SIB 28 02 24

SERVICE ACTION: DOUBLE CLUTCH TRANSMISSION REWORK AT TRANSFER CASE

U11 (X1 Sports Activity Vehicle)	U10 (X2 Sports Activity Coupe)
----------------------------------	--------------------------------

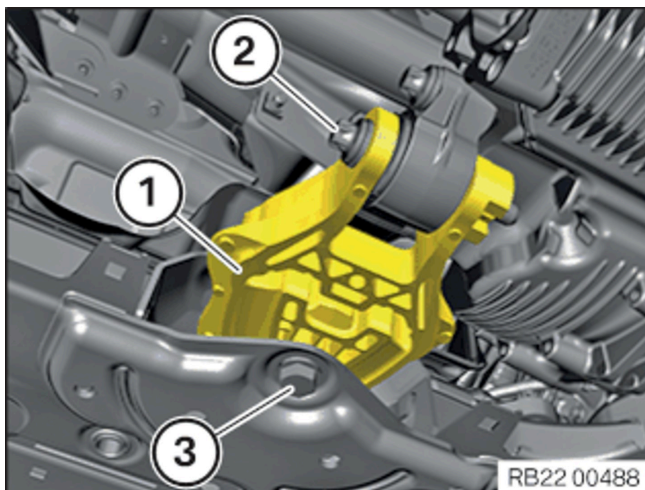
Micro-movements combined with frictional corrosion can increase wear on the longitudinal splined connection between the double clutch transmission (DCT) and the transfer box.

Add spacers at the connection between the DCT and transfer box to decrease micro-movements.

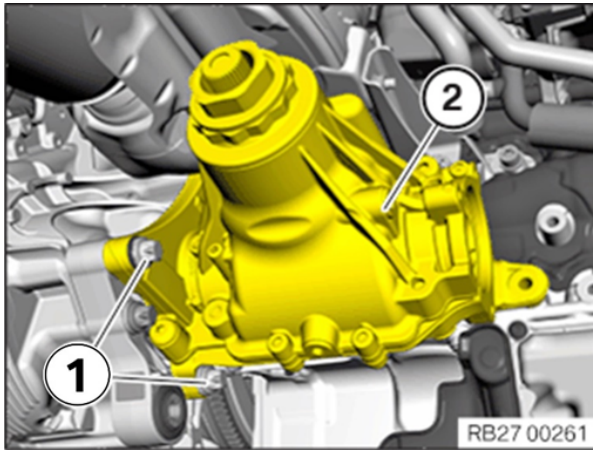
Remove the two bolts (1) on the transfer case.

Reinstallation: Replace both bolts

Tighten to 100 Nm and torque angle 90°

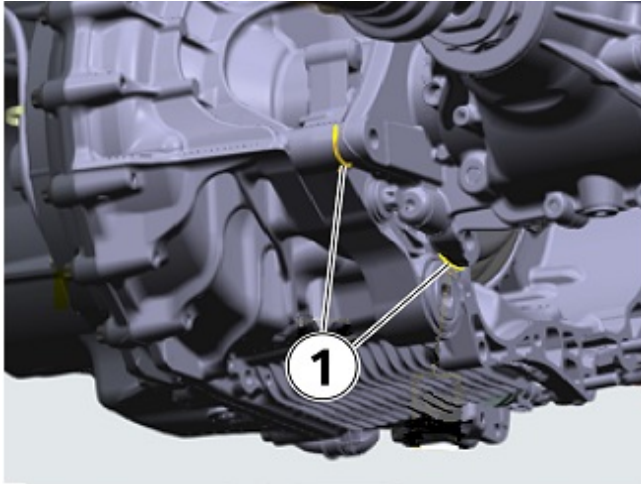
Install washers between the link and transfer case. It may be necessary to slightly push the transfer case to the side to install the washers.
